Quantization Noise Feature in COM Matlab Code

COM Commit Request Number 4p6_5

**Hossein Shakiba
Huawei Technologies Canada
October 2024**

Background

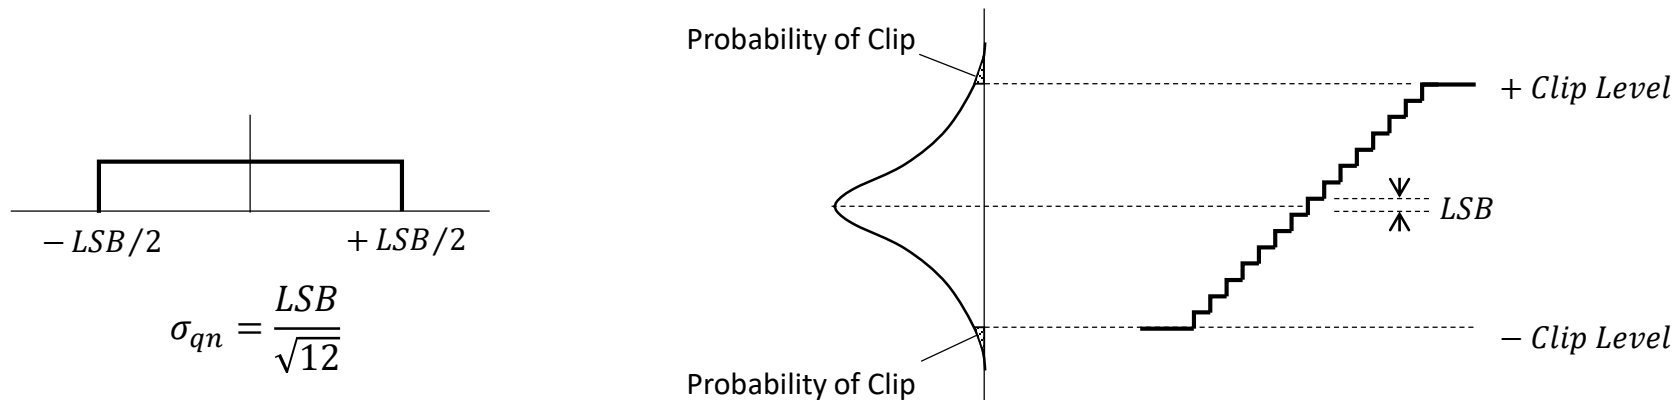
- Quantization noise is a new noise term added between CTLE and RxFFE

- It is modeled by a uniform distribution over $-LSB/2$ to $+LSB/2$

- ADC clip level is chosen so that clipping frequency is low
 - ❖ User defined and defaulted to the target error rate (parameter `adc_clip_rate`)
- For details see contribution [shakiba_3dj_02_2405.pdf](#)

Changes to the Code (6 of 8)

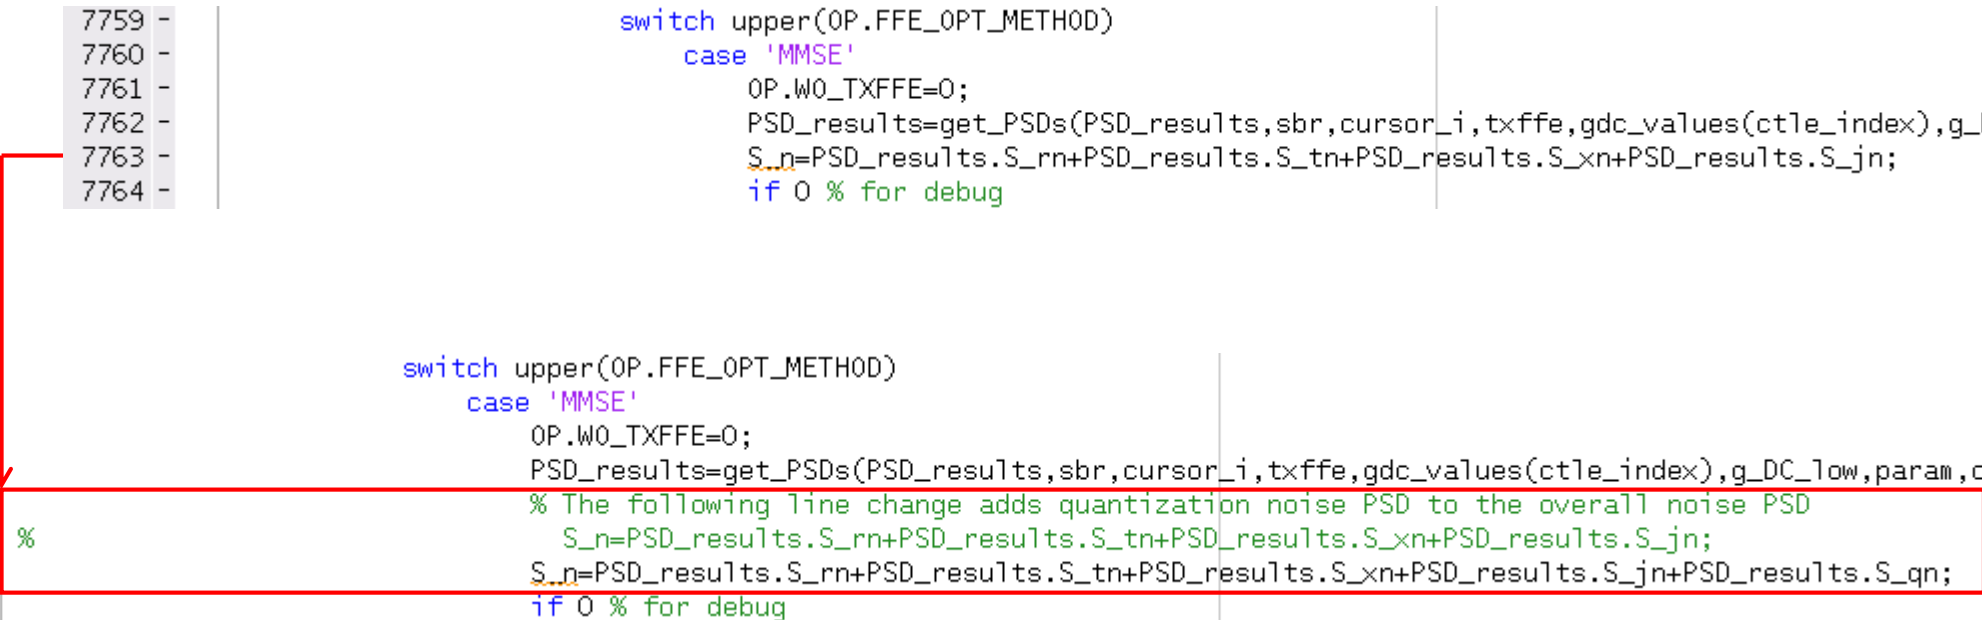
6) Insert 1 line and change 1 line

- ❖ Adds quantization noise PSD to the overall PSD

7820 - | switch upper(OP.FFE_OPT_METHOD)
7821 - |     case 'MMSE'
7822 - |         OP.WO_TXFFE=0;
7823 - |         PSD_results=get_PSDs(PSD_results,sbr,cursor_i,txffe,gdc_values(ctle_index),g_DC_low,param,chdata,OP);
7824 - |         % The following line change adds quantization noise PSD to the overall noise PSD
7825 - |         S_n=PSD_results.S_rn+PSD_results.S_tn+PSD_results.S_xn+PSD_results.S_jn;
7826 - |         S_n=PSD_results.S_rn+PSD_results.S_tn+PSD_results.S_xn+PSD_results.S_jn+PSD_results.S_qn;
7827 - |         if 0 % for debug
```
